Drawing Change Notice

CHANGE DOCUMENT NO.
24590-PTF-VDCN-MS-10-00007

JOB NO.	TITLE FOR CHANGE NOTICE
24590	UFP-VSL-00062A Redesign

JUSTIFICATION FOR CHANGE	CAUSE CODE
Based on the re-analysis of UFP-VSL-00062A, per calculation 24590-PTF-MVC-UFP-00023, for revised seismic conditions and design evolution, required a redesign of the vessel.	01 and 23

2 1A VESSEL ELEVATION
SCALE: ⅜" = 1'-0"

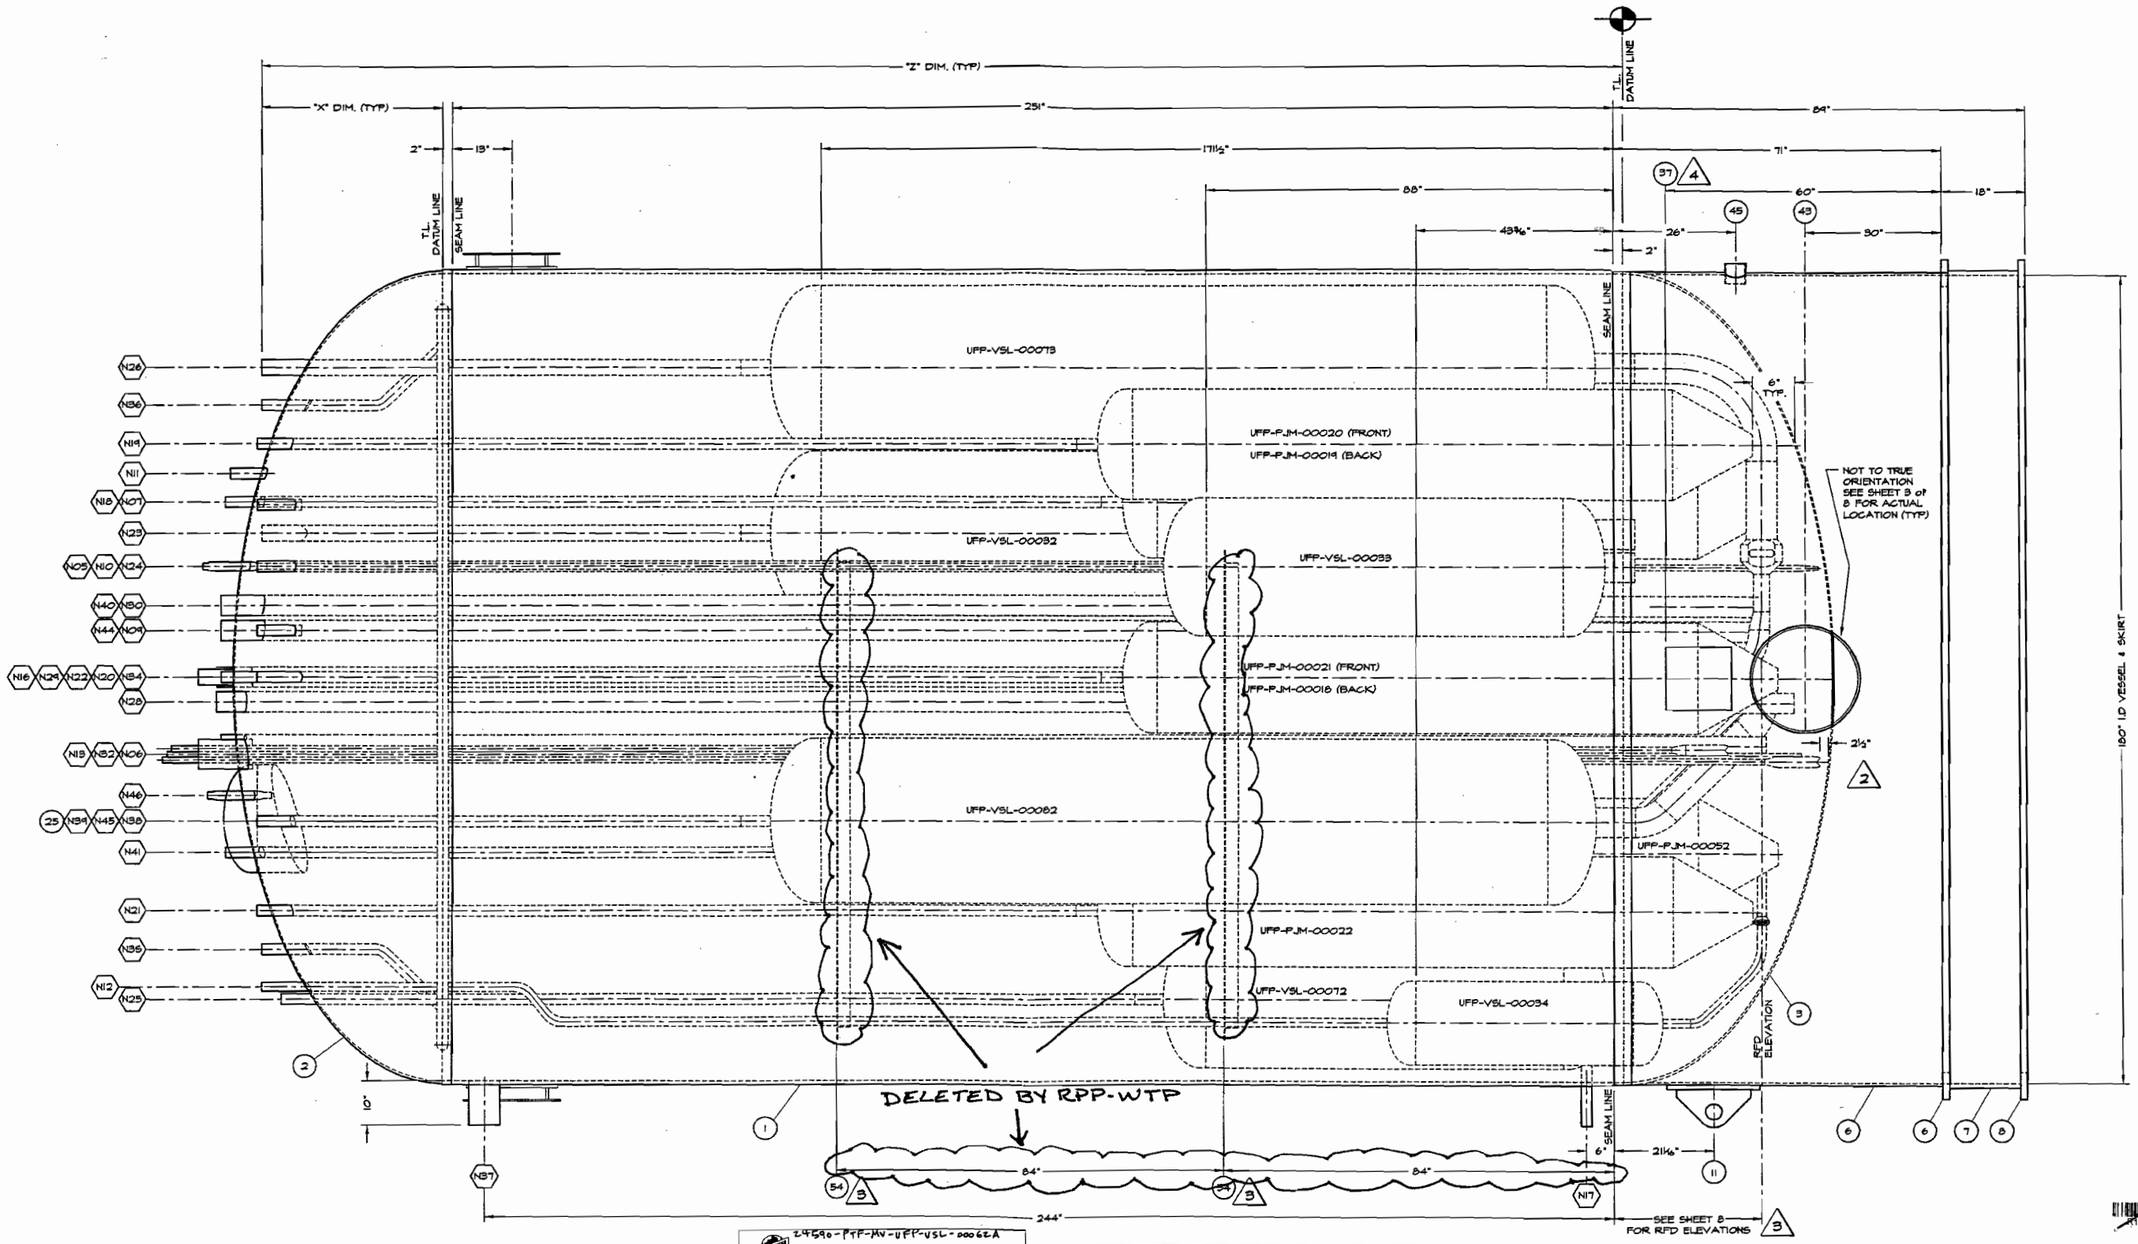
a.) Vessel Elevation View:

(1.) Delete supports and associated part bubbles depicted on drawing.

(2.) Delete support dimensions depicted on drawing.

△4 △3 △2 △1A VESSEL ORIENTATION
SCALE: 3/8" = 1'-0"

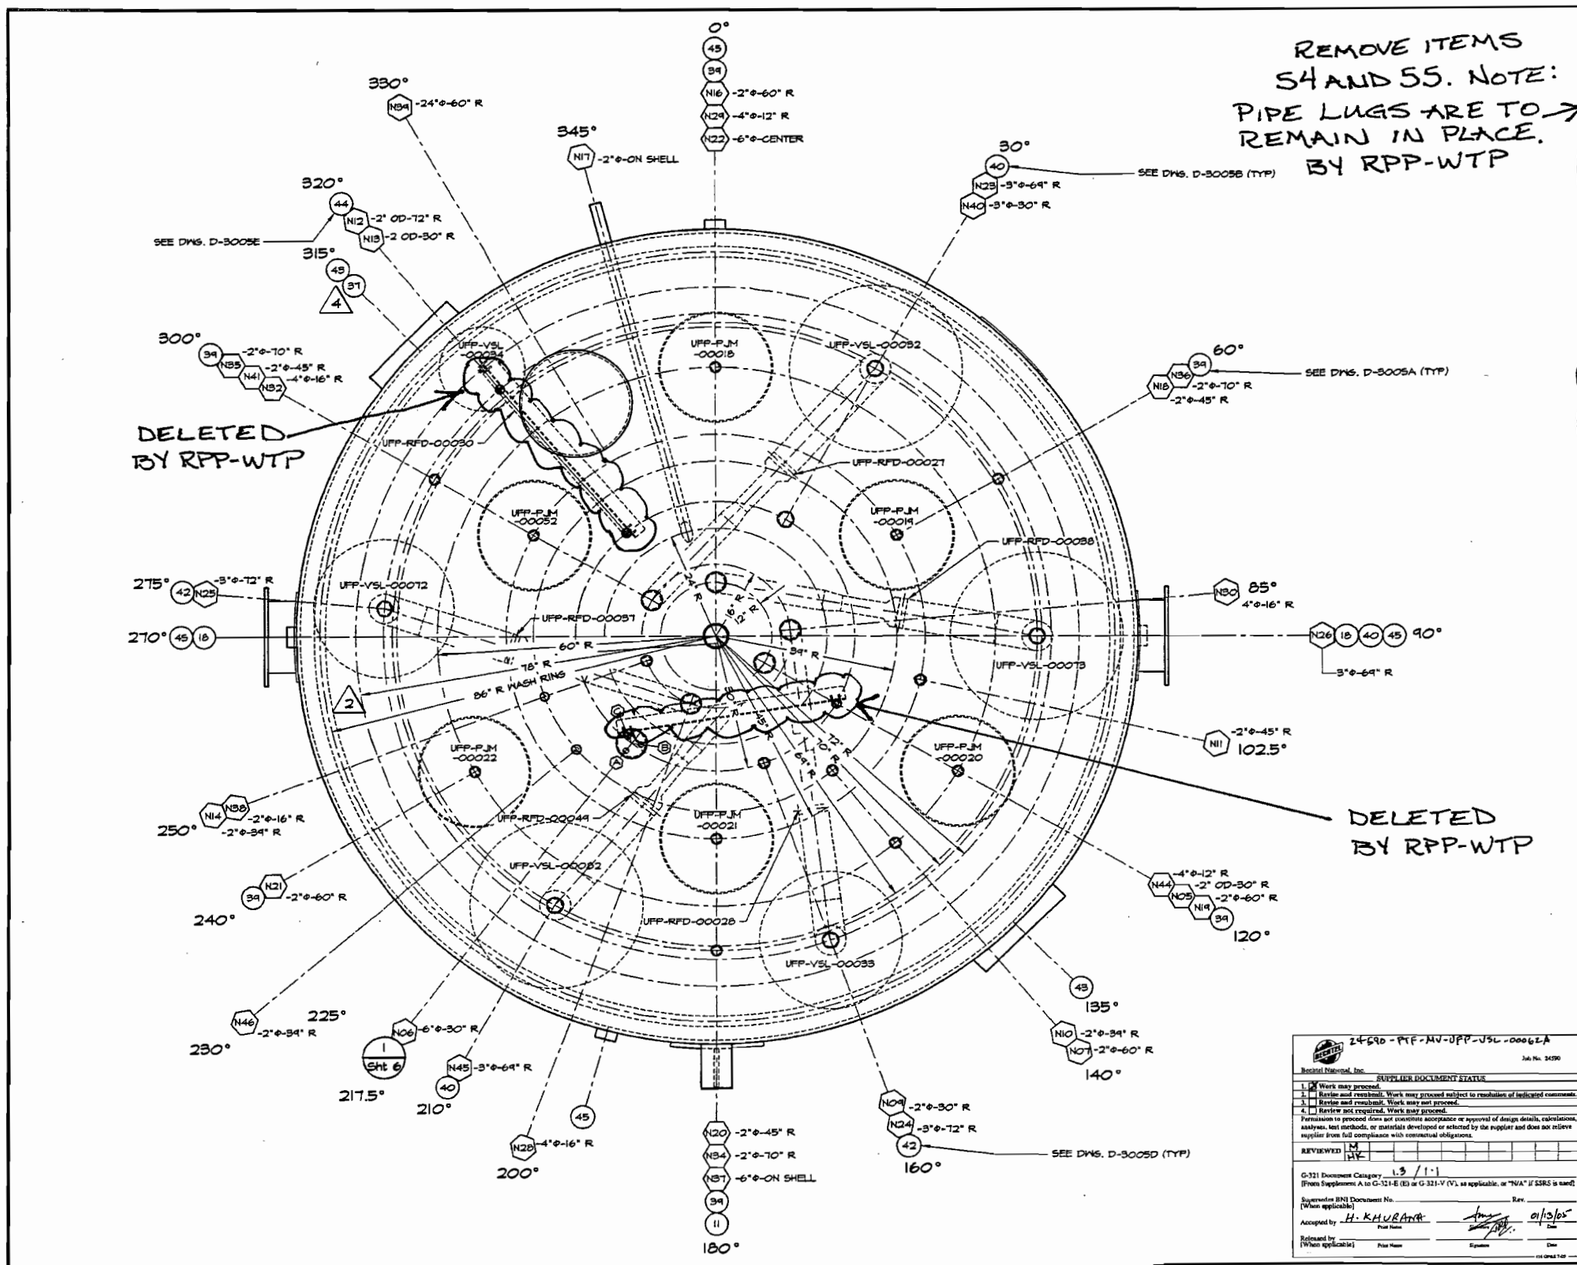
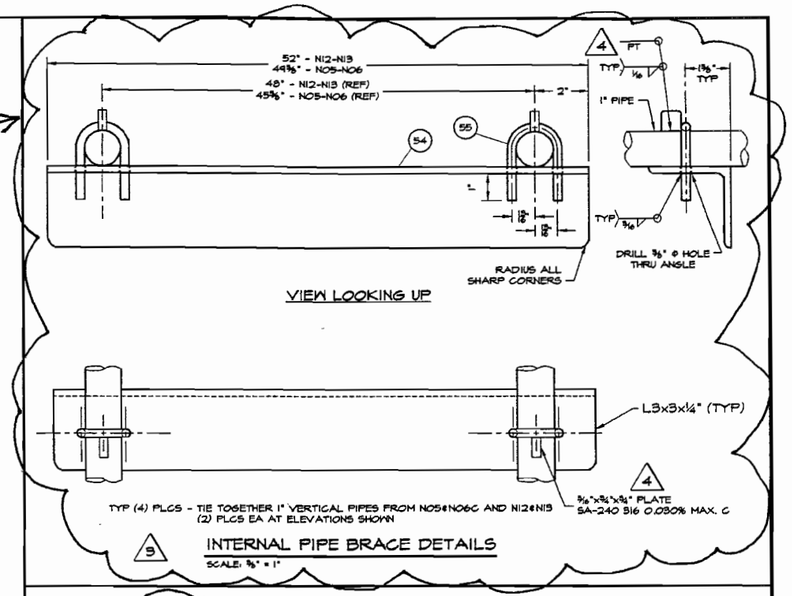
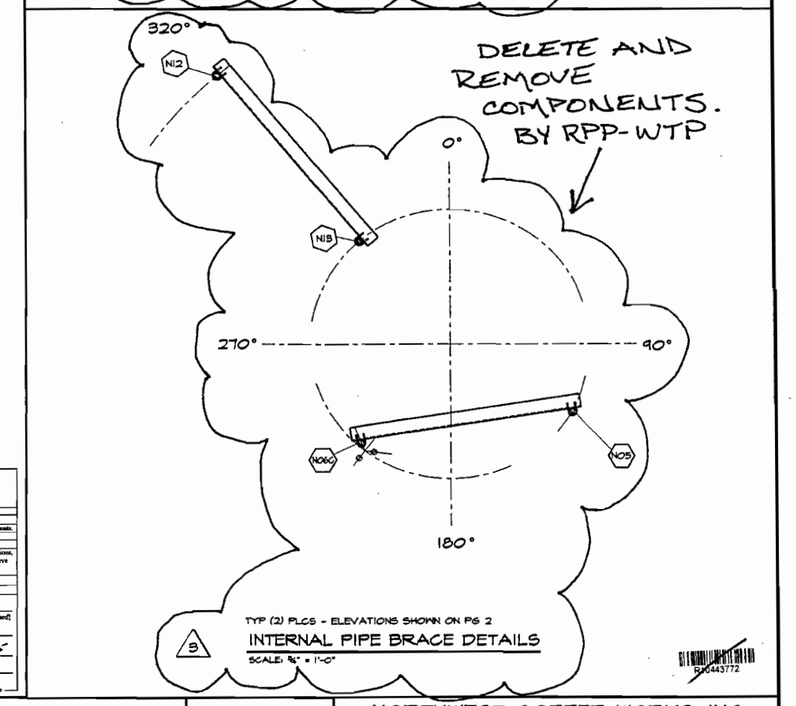
a.) Vessel Orientation: Delete supports as shown.

b.) Internal Pipe Brace Details: Remove items 54 and 55. NOTE: Pipe Lugs are to remain in place.

c.) Internal Pipe Brace Details: Delete detail and remove components.

REMOVE ITEMS 54 AND 55. NOTE: PIPE LUGS ARE TO REMAIN IN PLACE. BY RPP-WTP

ELEVATION

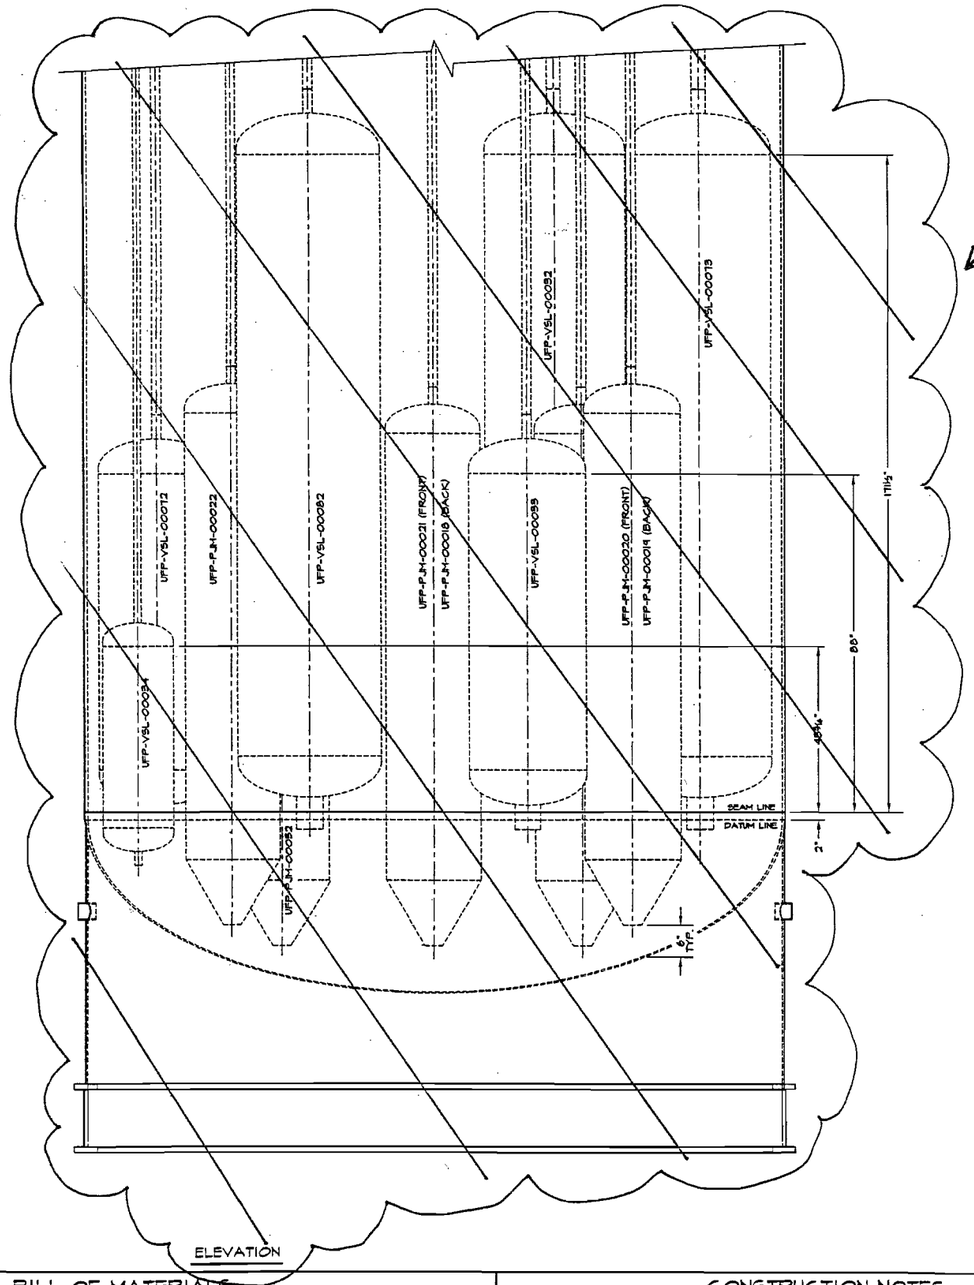
a.) Elevation View: Delete Elevation View and replace with NORTH ELEVATION VIEW shown on Attachment 1, page 5 of this VDCN.

DELETED BY RPP-WTP

INTERNAL VESSEL SUPPORT ORIENTATION
SCALE: ¾" = 1'-0"

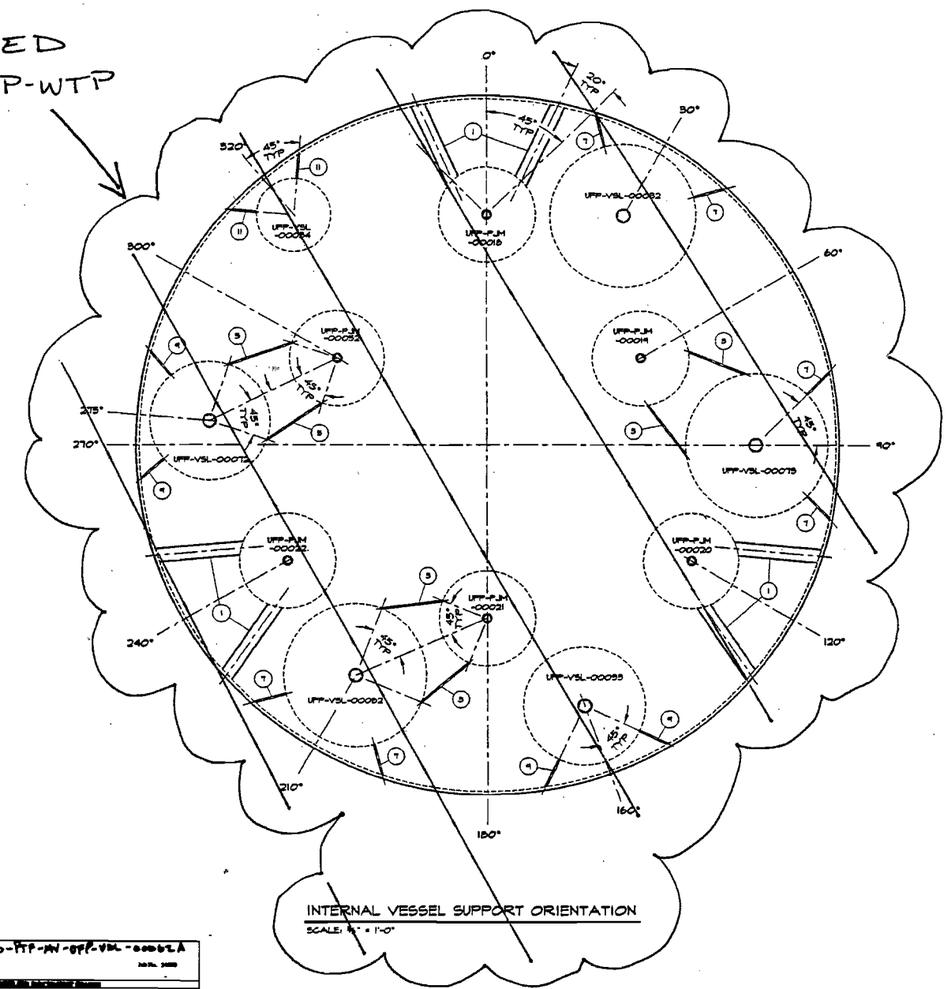
b.) Internal Vessel Support Orientation: Remove view as this will be covered in Sections B-B, C-C, D-D, E-E, F-F, and G-G shown on Attachment 1, page 5 of this VDCN.

SECTION B-B
SCALE: 1/16

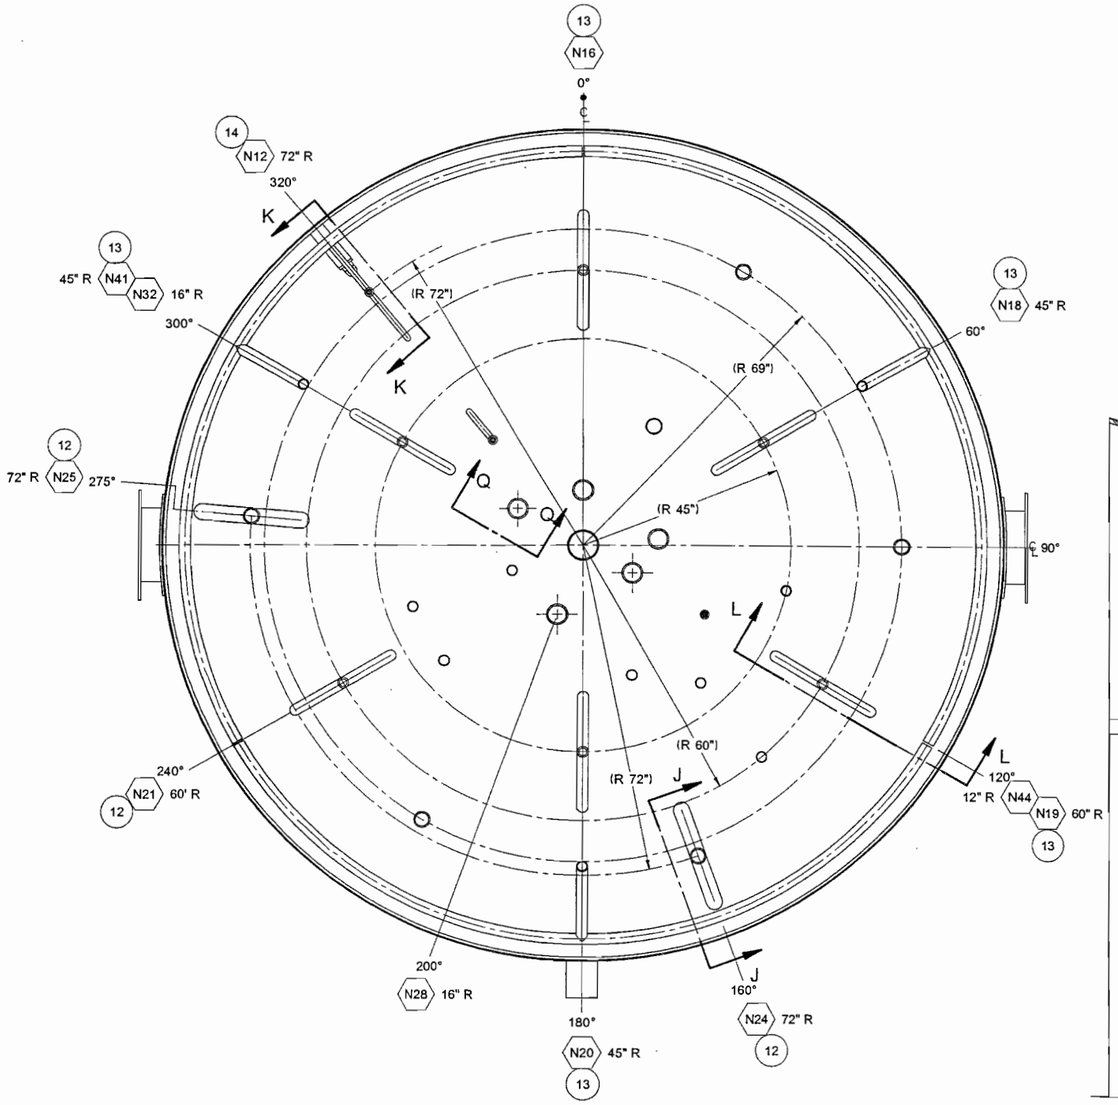
d.) Add SECTION B-B shown on Attachment 1, page 6 of this VDCN.

13 SECTION L-L
THERMAL EXPANSION S-BEND
SCALE: 1/10

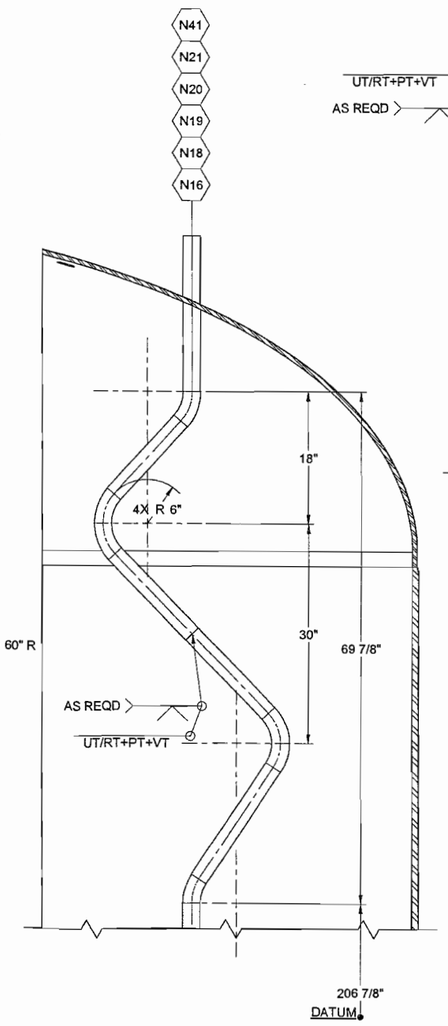
g.) Add SECTION L-L and item 13 THERMAL EXPANSION S-BEND shown on Attachment 1, page 6 of this VDCN.

14 SECTION K-K
THERMAL EXPANSION S-BEND
SCALE: 1/10

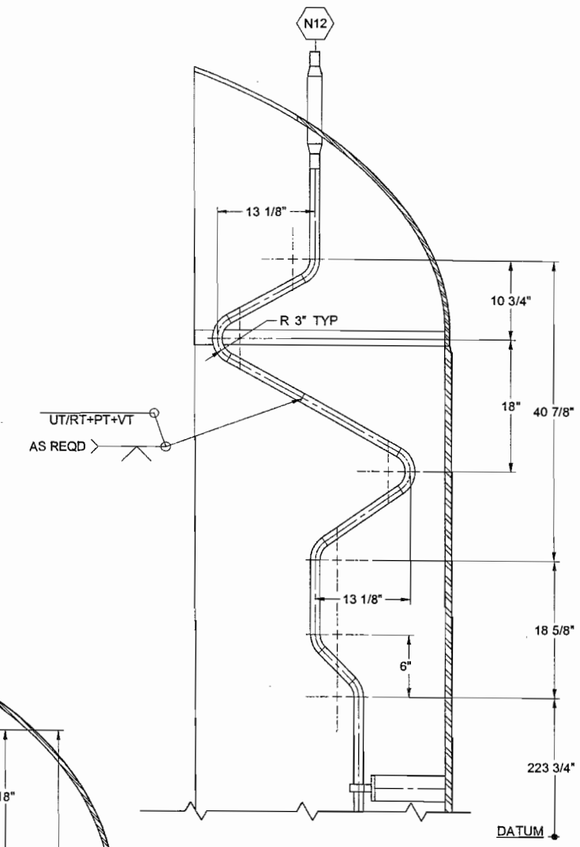
f.) Add SECTION K-K and item 14 THERMAL EXPANSION S-BEND shown on Attachment 1, page 6 of this VDCN.

SECTION Q-Q
SCALE: 1/10

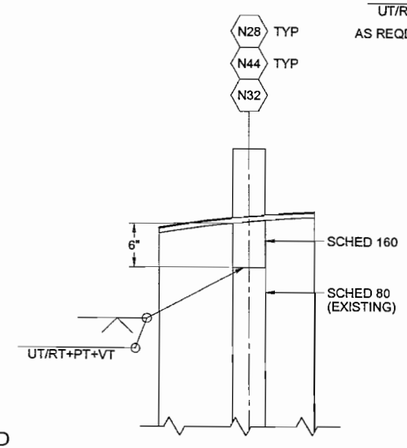
e.) Add SECTION Q-Q, 4" SCH 160 INLET TO INTERNALS shown on Attachment 1, page 6 of this VDCN.

12 SECTION J-J
THERMAL EXPANSION S-BEND
SCALE: 1/10

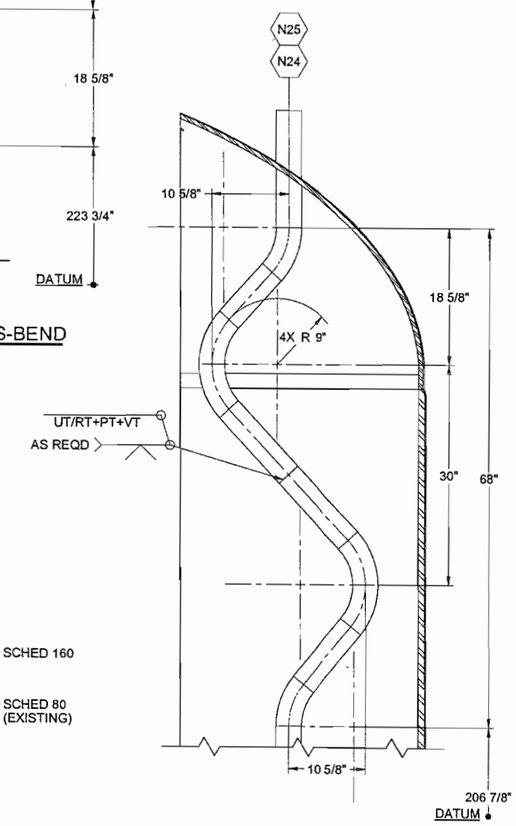
e.) Add SECTION J-J and item 12 THERMAL EXPANSION S-BEND shown on Attachment 1, page 6 of this VDCN.
